Validation Report

VALIDATION OF THE CDM-PROJECT: YULONG TONGLI WHR PROJECT,

REPORT NO. 1017077

2008, May 29

Specific Investment of Waste Heat Recovery Projects in China (Source: UNFCCC/TÜV SÜD)

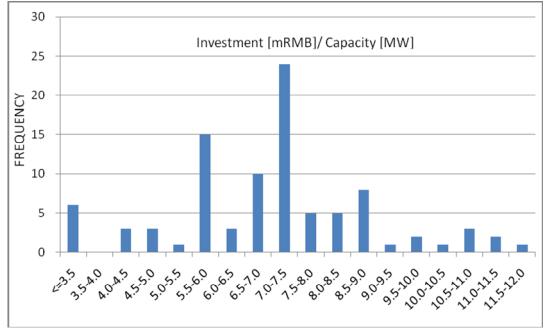
The DOE shall confirm how it has validated that the input values of the IRR meet the requirements of EB 38 paragraph 54 (c).

The input values have been carefully checked and are all based on a third party assessment (The Feasibility Study Report issued by Luoyang heavy industry mine machinery engineering design institute).

To provide additional certainty that the figures used for the IRR calculation are applicable we are comparing the main parameters with other CDM projects of the same type. For the Yulong WHR project the specific investment per power is 6.65 Mio. RMB / MW and the specific opera-tional costs per year are 1.14 Mio. RMB / MW. The average specific investment per power in China (based on the evaluation of 120 waste recovery projects in China that applied or are ap-plying for CDM) is 7.273 Mio. RMB / MW (see figure below); the average specific operational costs are 1,069 Mio. RMB / MW. For the operational hours the average is 6415 h whereas Yu-long is calculated with 6216 h, the grid tariff is 0.326 RMB / kWh compared to 0.335 RMB / kWh as the Chinese average. Hence, it can be confirmed that the Pingyuan project does not apply unreasonable assumptions.
